RTS-TB-033

10-May-2016

## KP Series Panel Microphone Input Impedance can cause Inconsistent Output Levels

Close-up View of resistor locations R403 and R602:

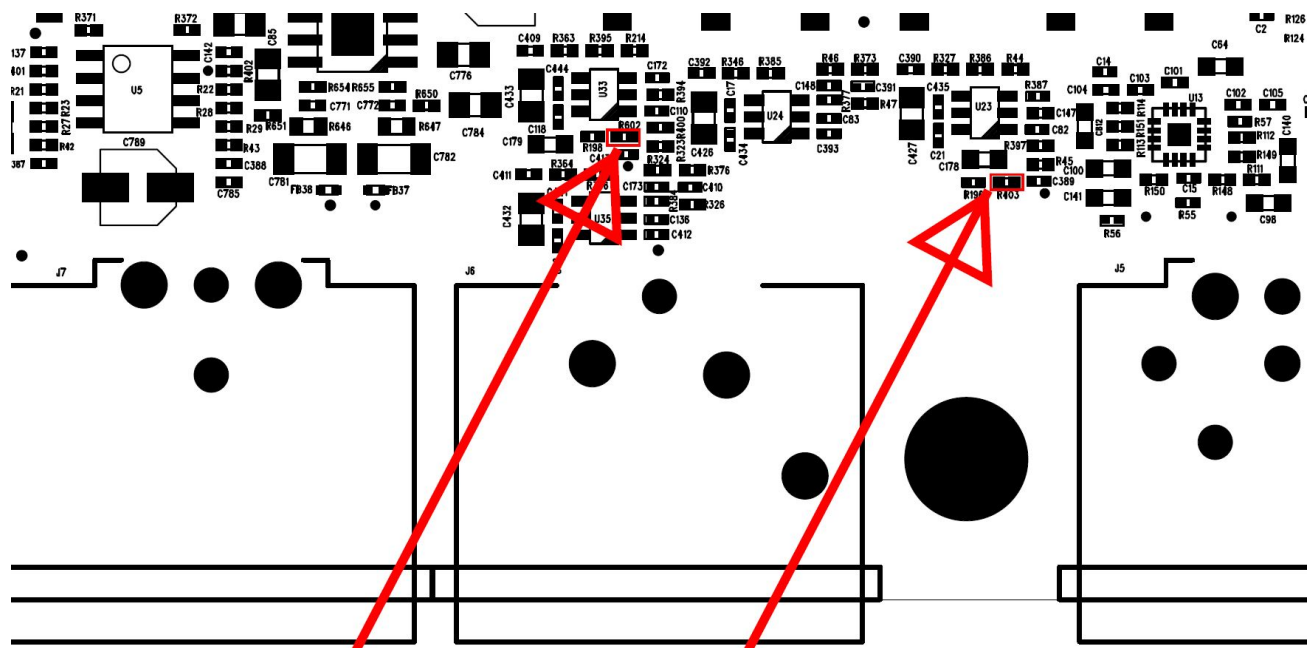
1. Remove AC power from the KP series panel and place the panel onto an ESD safe work surface.
2. Remove the top cover from the KP series panel.
3. Disengage all cable connections to the Main PCBA and remove all screws securing the Main PCBA to the base chassis.
4. Remove the Main PCBA and place this onto a static protective work surface.
5. Identify resistor locations R403 and R602 on the Main PCBA. These are shown with the red arrows in the following diagram of the Main PCBA:

6. Carefully unsolder resistors R403 and R602. These 21.5 kOhm parts can be discarded.
7. Replace R403 and R602 with the 2 kOhm 0402 SMT parts specified earlier in this document (SAP# 4998149308 or equivalent).
8. Reinstall the Main PCBA into the chassis. Make sure to properly mate all cable assemblies and install all screws securing the Main PCBA to the base chassis.
9. Reinstall the top chassis cover and secure with screws.

This rework should reduce the input impedance of both front and rear panel microphone circuits from 21.5 kOhms to 2 kOhms. This should eliminate any output level inconsistencies due to microphones.
